**TOWN OF MOUNTAIN VILLAGE
REGULAR DESIGN REVIEW BOARD MEETING AGENDA
THURSDAY MAY 1, 2025, 10:00 AM
MOUNTAIN VILLAGE TOWN HALL
455 MOUNTAIN VILLAGE BLVD, MOUNTAIN VILLAGE, COLORADO
TO BE HELD HYBRID THROUGH ZOOM:
<https://us06web.zoom.us/j/85097485733>
Meeting ID: 850 9748 5733**

Case Summary: Chris Hawkins of Alpine Planning is requesting Design Review Board (DRB) approval of an Initial Architectural and Site Review (IASR) for a new single-family detached condominium on Lot 161A-4 Unit 8, TBD Raccoon Lane. The lot is approximately 0.16 acres and is zoned multi-family. The proposed design consists of a two-story structure. The overall square footage of the home is approximately 7,543 gross square feet. Because of the home's location near the top of Coonskin Ridge, additional development regulations must be addressed in addition to the general Design Review Standards – specifically, CDC Section 17.5.16: Ridgeline Lots. The applicant has provided all the required materials for the IASR for the proposed home.

A3.1
SCALE: 1/4" = 1'-0"

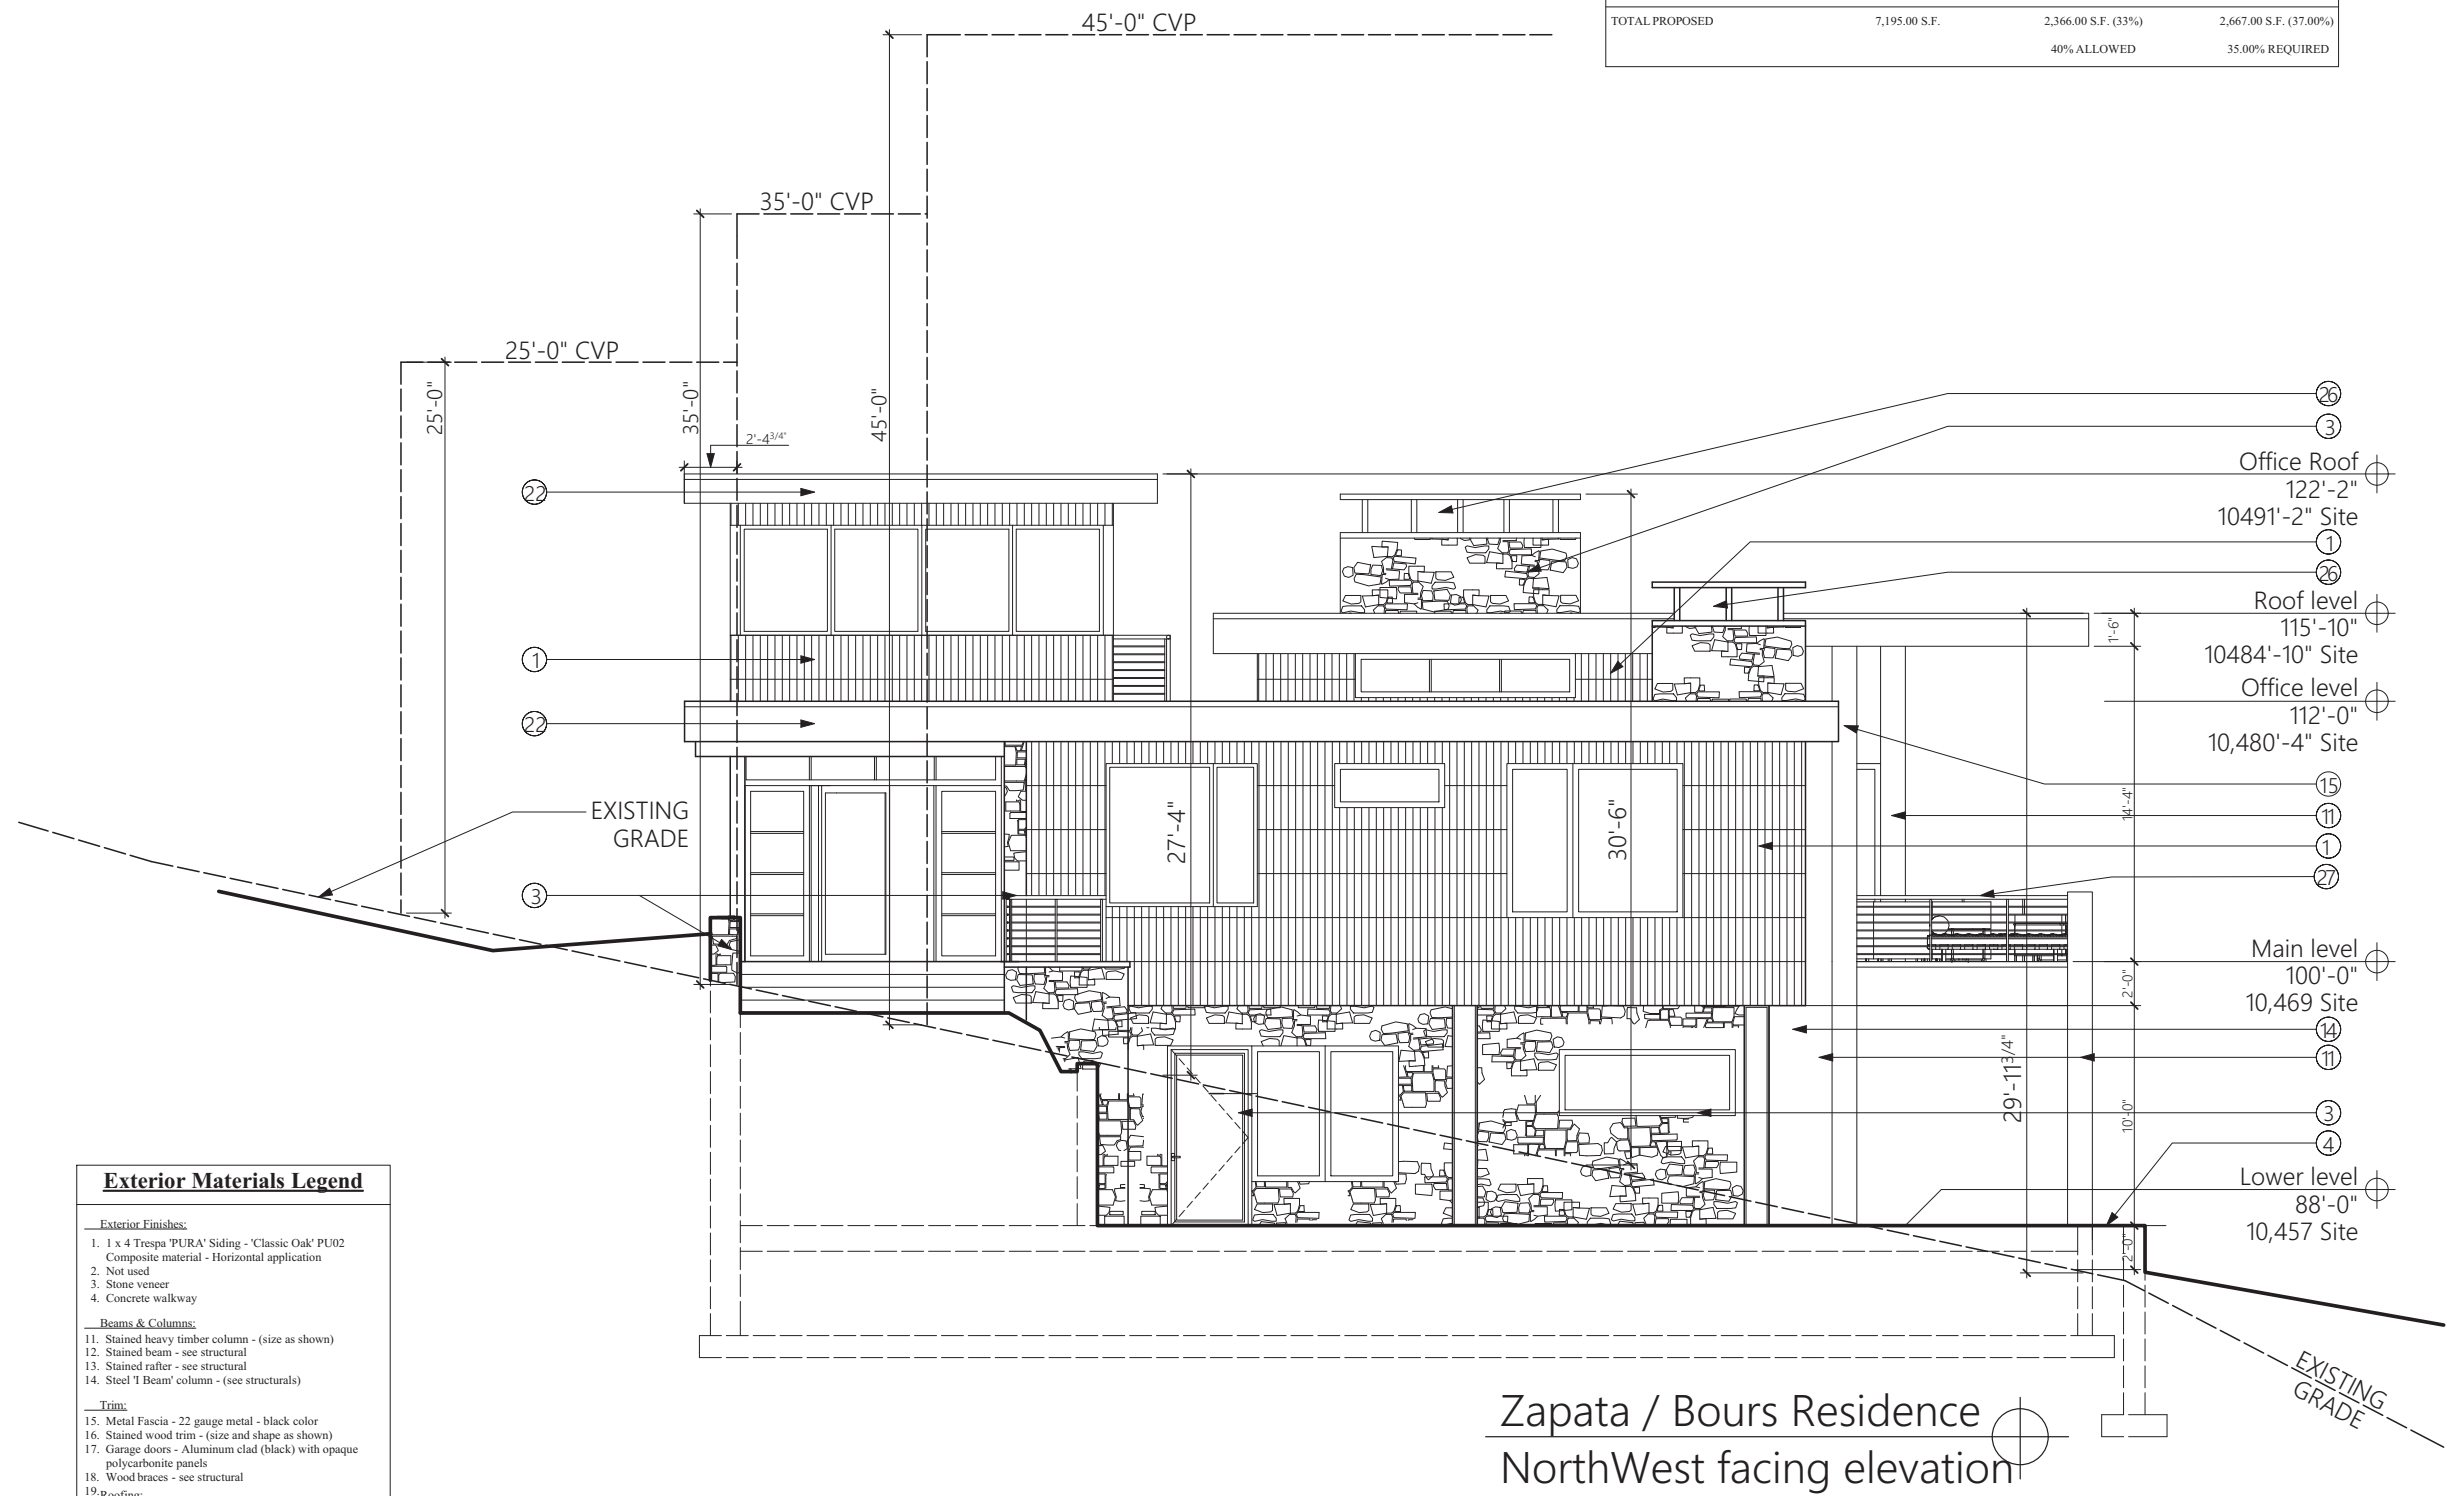
Staff: The home is a modern home that incorporates light stone in a horizontal arrangement composite oak siding, fir columns, steel railings, and black clad windows and doors. The home is comprised of a light neutral pallet. Composite wood requires specific approval by the DRB. The applicant has proposed EPDM roofing material with sections of ballasted material. EPDM roofing requires a design variation. A drawing detail of the roof material was provided on Sheet A2.4. The ballast will be 2 ½" deep with ½" diameter black stones. The fascia will be 22-gauge black metal. Staff recommends using a thicker metal to prevent oil canning. The elevations were revised to account for the changes in floor plans. Windows were removed from the lower southeast elevation. The lower-level patio was removed from the southwest elevation. The total stone percentage increased from 35.13% to 37.00%.

Zapata / Bours Residence
SouthWest facing elevation

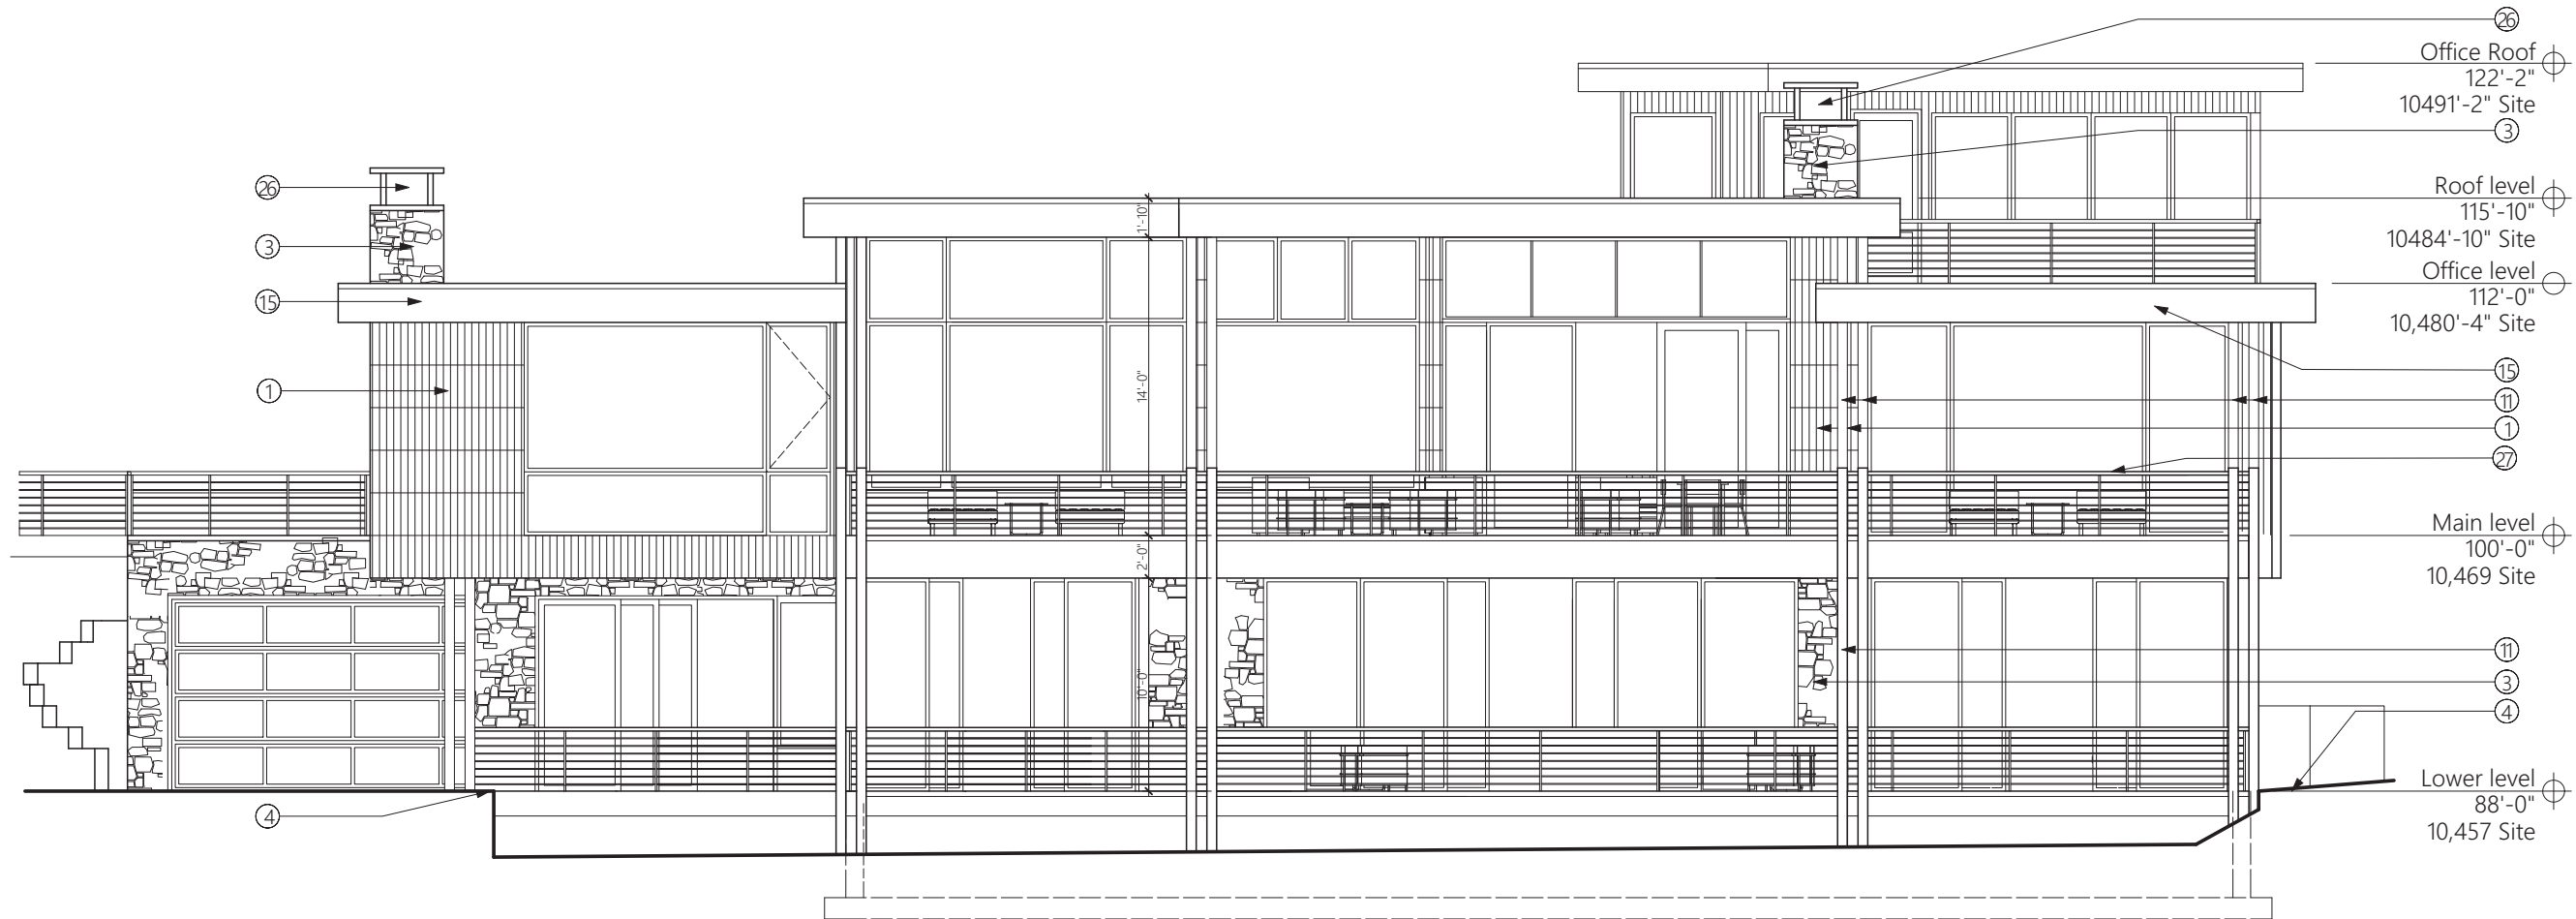
Much of the fenestration is located on the southwest elevation of the home. The CDC states "window placement and size shall be sensitive to light spill to adjacent properties". The Southwest facing elevation also faces the gondola corridor. The DRB should discuss whether the amount of fenestration on this elevation should be broken up to avoid large areas of illumination from being seen off property at night. The applicant provided the recess details for the windows and doors on Sheet A2.2. The windows and doors meet recess depth requirements. A full window and door schedule should be provided prior to final review.
